SEWAGE DISPOSAL TESTING

STATE OF MARYLAND - DEPARTMENT OF HEALTH AND MENTAL HYGIENE

HOWARD COUNTY HEALTH DEPARTMENT
ENVIRONMENTAL HEALTH SERVICES

ROAD AND DESCRIPTION Corner Windsor Forest Rd. & Long Corner Rd.

INDICATE NORTH. - NAME ADJOINING ROADWAY AS BASE LINE.

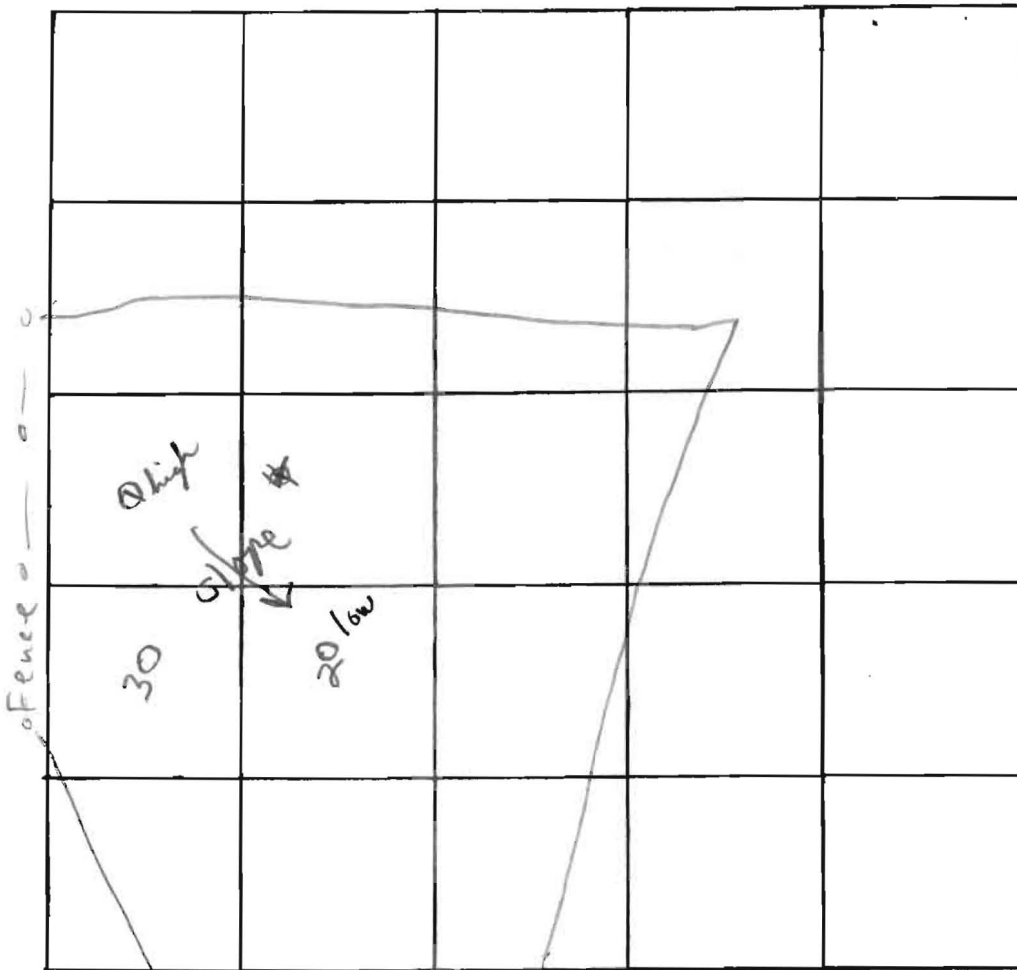
DATE	TEST NO.	DEPTH	PRE-WET		TEST - 1" DROP		TIME
			START	STOP	START	STOP	
5/22/74	1 high	11'	1:02	1:15	1:15	1:33	18 min.
	1a	4'	1:01	1:06	1:06	1:09	3 min.
	2 low	11 1/2'	1:06	1:09	1:09	1:15	6 min.
	2a	5'	1:07	1:12	1:12	1:18	6 min.
	3	10'	visual; clay to 5' shale & good soil below				
	4	10 1/2'	visual; clay to 5'; shale & good soil below

REMARKS _____
 TYPE OF SOIL sandy loam & shale
 TESTED BY F.S. & C.B.S. ALSO PRESENT: _____

Drywell to have 130 sq. ft. effective sidewall absorption over per bedroom to begin below the first 4 ft. of non-absorbant soil. Maximum depth permitted for drywell is 11 ft below original grade. Place the drywell 105 ft from the rear lot line and 75 ft from the left lot line, as seen when facing the lot from Long Corner Rd.

WILLIAM FREDERICKS & COMPANY
 CIVIL ENGINEERS & LAND SURVEYORS
 1111 BONIFANT STREET
 SILVER SPRING, MD. 20910

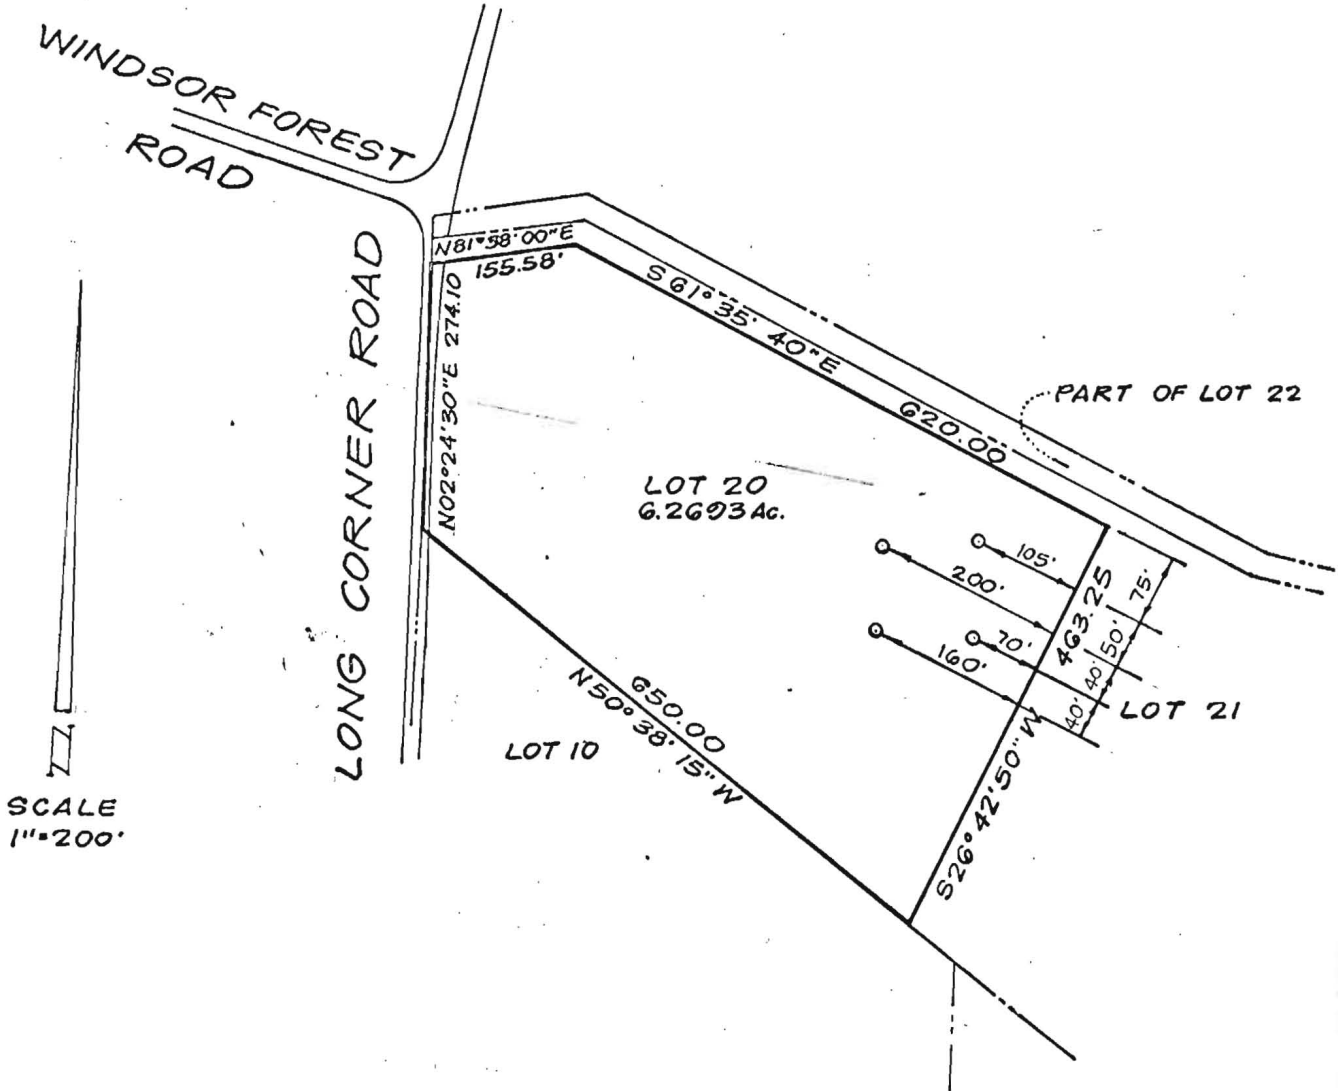
The lot shown hereon complies with minimum ownership widths and lot area as required by Maryland State Department Health Regulations.

APPROVED for Private Water
 & Private Sewer
 DATE 8/6/74 [Signature]
 COUNTY HEALTH OFFICER
